Revision	Description	Date
A	Initial Release	?
B	As built changes: E990211-00-C	5/99
C	1. Added compensation networks to coil drivers with capacitors, Cadd1 through Cadd10 and resistors Radd1 through Radd5 2. Changed coil driver 183 ohm (R202, R216, R229, R243, R256) to 125 ohm, 2 Watt for ITMX and ITMY and to 183 ohm 1 watt on all other chassis. 3. Cadd1 through Cadd14 added to board to stabilize and limit high freq gain of 1Hz zero, 40Hz pole compensation stage. 4. Dadd1 through Dadd20 added to coil driver for op amp input protection.	2/00
D	Added Radd6, Radd7, Radd8, Radd9 to terminate unused inputs of MAX333 switches per E010178-00.	5/99

Note:
402 ohm resistor and 10uF capacitor are not stuffed on LOS controllers for the RCM and BS.

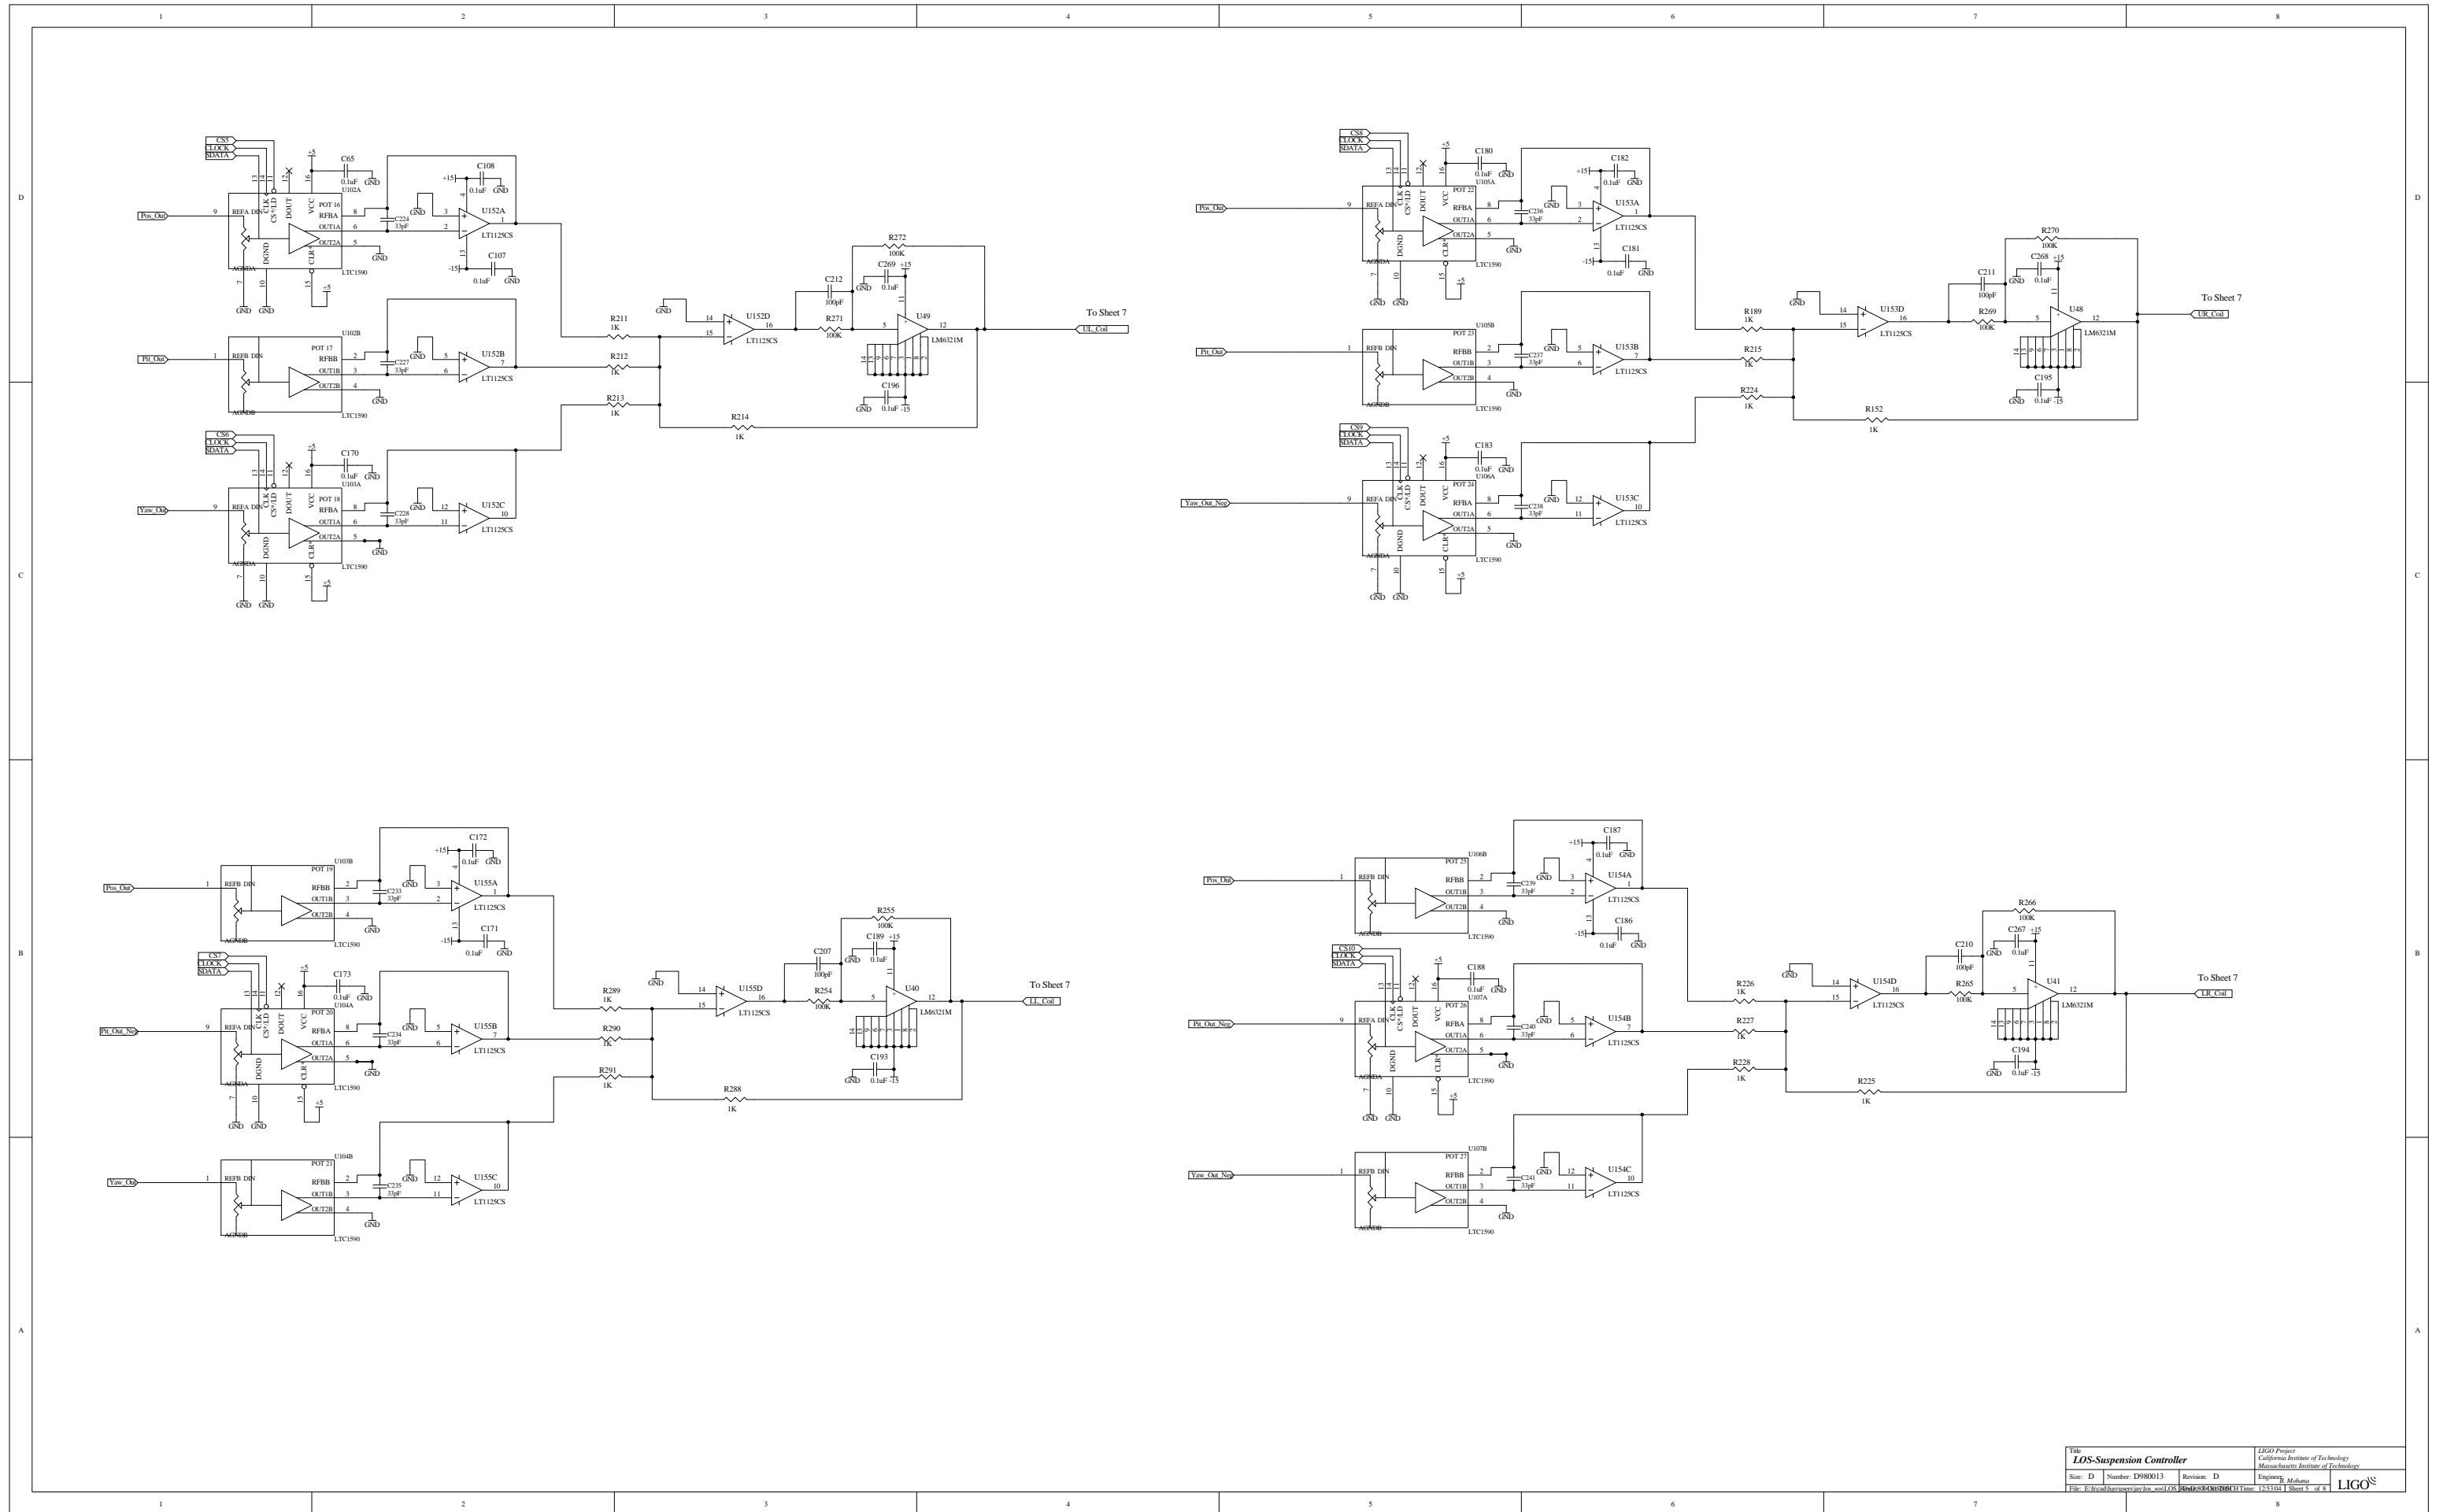
Note: PA85 feedback Cap and resistor added on bottom of the board

Note:
The wiring to the daughter card was changed after board manufacture. The actual connections to the board are made via wires to the coil driver outputs. The PD connections remain as shown.
An interface board (ref. D990022) is used for this function.
